1	2013/07/26	DF	TG	ISSUED FOR ADDENDUM 3			
0	2013/06/21	DF	TG	ISSUED FOR TENDER			
NO.	DATE	ENG.	BY	SUBJECT			
	REVISIONS

ROJECT No.	20132297 AS SHOWN		CITY OF NEW WESTMINSTER	4TH STREET PEDESTRIAN OVERPASS		
RAWN						
ESIGNED	TERESA GRGIC					
			ELECTRICAL	DRAWING NUMBER	REV. NO.	SHEET
			LIGHTING PLAN	2297-601	1	1 2

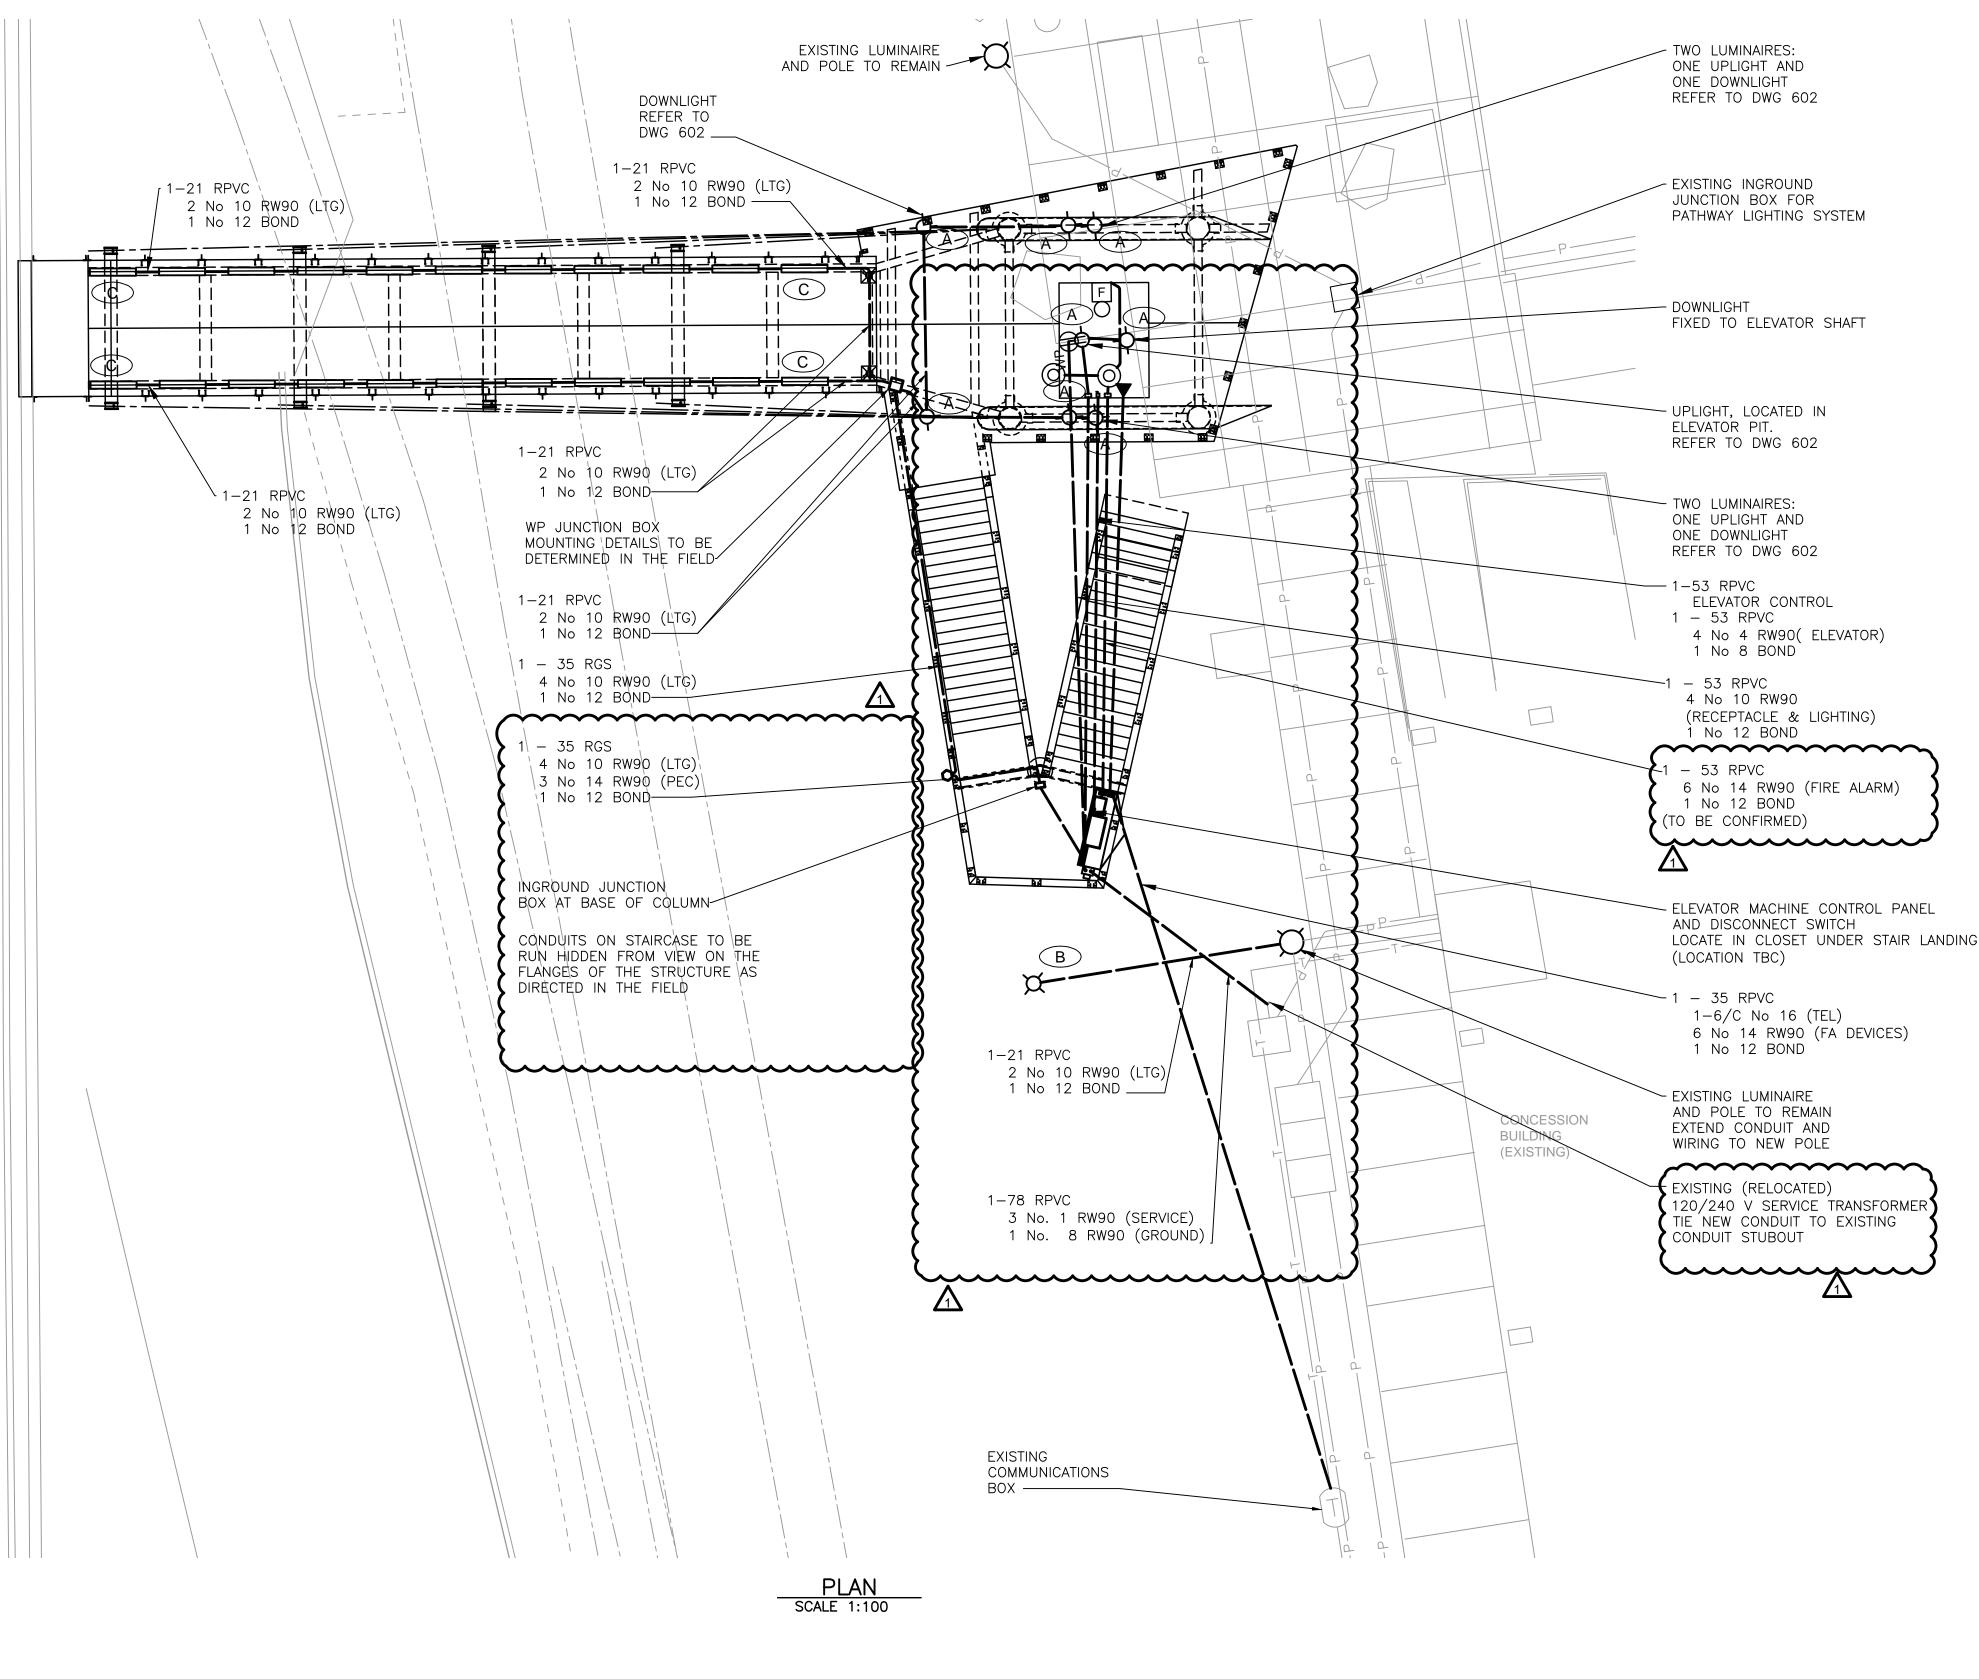
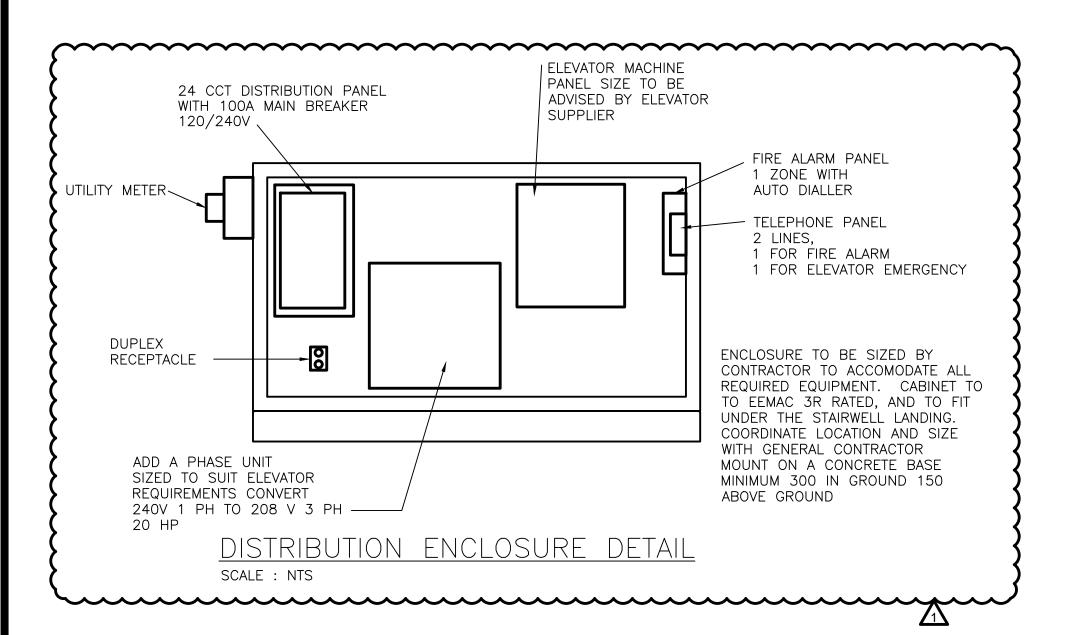
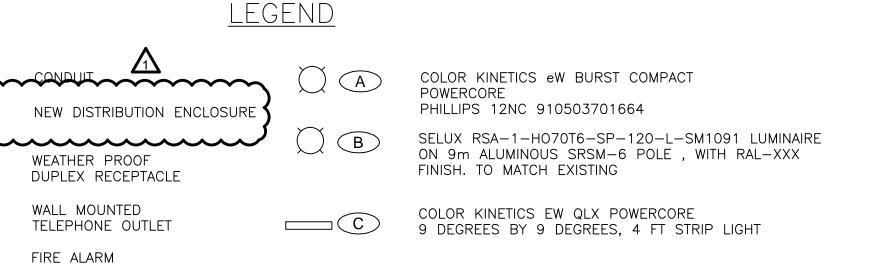
CURB LIGHTING, 1 CCT FOR EAST SIDE CURB LIGHTING, 1 CCT FOR ALL UP AND DOWN LIGHTS AND EXTERNAL LIGHTING FOR THE ELEVATOR. AN ADDITIONAL CIRCUIT IS REQUIRED

FOR THE ELEVATOR CAB LIGHTING NEEDS.

6. ALL NEW STRUCTURE LIGHTING, AND EXTERNAL ELEVATOR LIGHTING TO BE CONTROLLED FROM NEW LIGHTING CONTROL SYSTEM. UPGRADE CONTACTOR AS NEEDED TO ACCEPT THE ADDITIONAL LIGHTING CIRCUITS REQUIRED BY THIS CONTRACT. NEW POLE LIGHTING TO BE CONTROLLED FROM EXISTING LIGHTING CONTROL SYSTEM.
